Flight Procedures Cover Page	Task Action: FLIGHT CHECK	Task Type: SID	Estimated Chart Date: 11/27/2025	APWS Task ID: 7FE623F92BA440EAA335D5E032D399F3	APWS Project ID: 8CB1D84ACF1B49CC82A3AFB13FEB47A1
Procedure: ZIMMR FOUR DEPARTURE (RNAV)		Enroute: YES	Specialist: Palmer, Leo		Agreement Number:
Airport ID: KDEN			Airport City: DENVER		State: CO
Facility ID:	Facility Type:	Flight Inspection Remark Type: New FC Slot

PROCEDURE: ZIMMR FOUR DEPARTURE (RNAV)		AIRPORT NAME: DENVER INTL		AIRPORT ID: KDEN	SPECIAL CONTROL NO: SG-07-005-25
FAC ID: ZIMMR4		CITY: DENVER		ST: CO	ORIG CHART DATE: 11/27/2025
DFL TYPE: PROC/D	THIRD PARTY: <input type="checkbox"/> YES	EST. TIME ON SITE: 1.0	REIMB. NUMBER:	PTS TASK ID: 7FE623F92BA440EAA335D5E032D399F3

AUTOMATED AL-9077 ZIMMR DEPARTURE

DENVER INTL AIRPORT
DENVER, CO (KDEN)

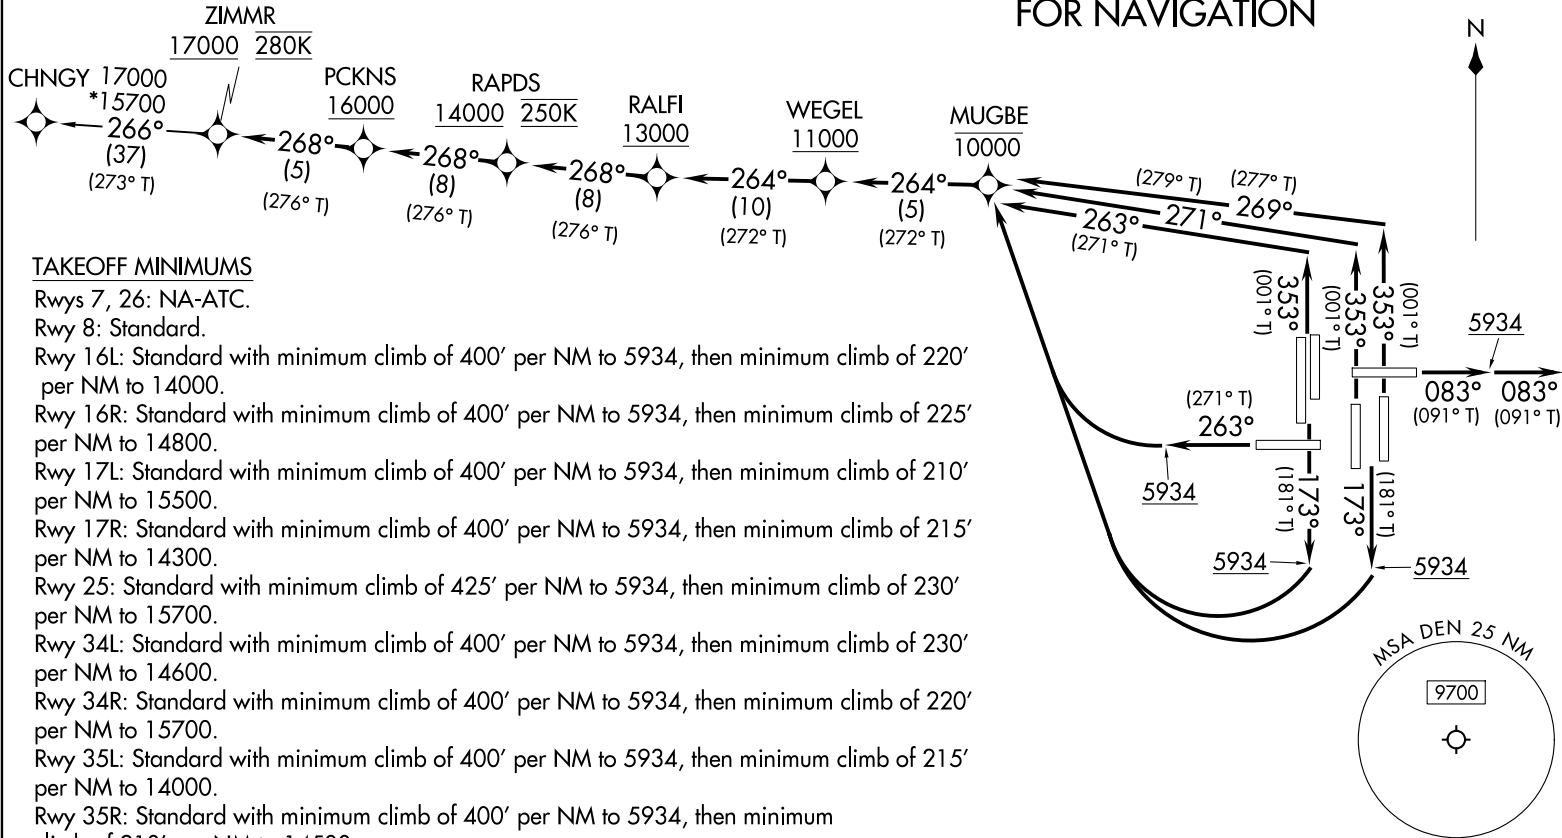
Amendment to Add crossing altitudes to fixes on SID ZIMMR FOUR (RNAV).
 - ADD 'WEGEL' FIX WITH AOA 11000 TO RUNWAY TRANSITIONS. - ATC REQUEST.
 - ADDED MSA - IAW 8260.46 DOCUMENT STANDARDS.
 - INCREASE RALFI "IF" MINIMUM CROSSING ALTITUDE FROM 12000 TO 13000. - ATC REQUEST.
 - ADDED SPEED RESTRICTIONS OF 250 KIAS AND 280 KIAS TO RAPDS AND ZIMMR WP RESPECTIVELY. - ATC REQUEST.
 - ENROUTE TRANSITION MOCA LOWERED FROM 15800 TO 15700
 ACTIVE AIRPORT DATA USED: PUB'D 06/20/19.

- 8260.15C CODING FORM CORRECTION: RWY 17R AND RWY 25 VA LEG ALTITUDE CHANGED FROM "AT/BELOW 5934" TO "AT/ABOVE 5934".

TAKEOFF RUNWAYS 16L/R, 17L/R: Climb on heading 173° to 5934, then right turn direct MUGBE at or below 10000, then on track 264° to cross WEGEL at or above 11000, then on track 264° to cross RALFI at or above 13000, thence. . .

. . .on track 268° to cross RAPDS at or above 14000 and at 250K, then on track 268° to cross PCKNS at or above 16000, then on track 268° to cross ZIMMR at or above 17000 and at 280K. Then on transition. Maintain FL230. Expect higher filed altitude 10 minutes after departure.

ZIMMR THREE DEPARTURE (RNAV)
(ZIMMR3.ZIMMR) 12AUG21

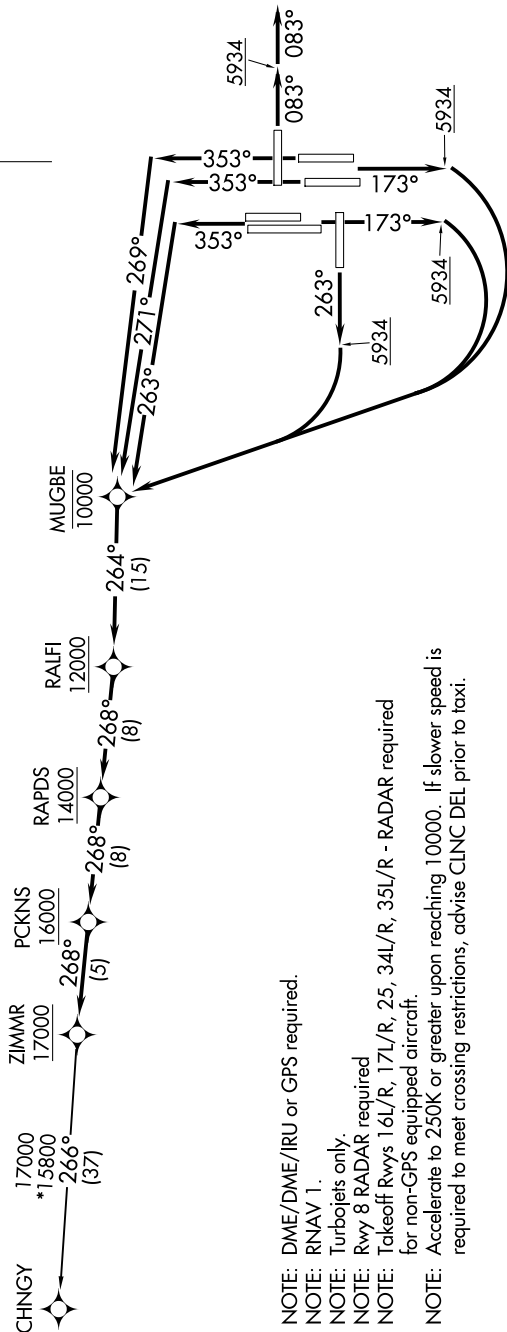
PROCEDURAL DATA NOTES: COMBINE APPLICABLE NOTES TO READ ““RNAV 1 – DME/DME/IRU or GPS REQUIRED.” ALSO, CHANGE “TURBOJETS” to “JETS.”

MSA/ESA: PER CRITERIA IN .46J, ADD AN MSA FROM ARP NEXT AMENDMENT.
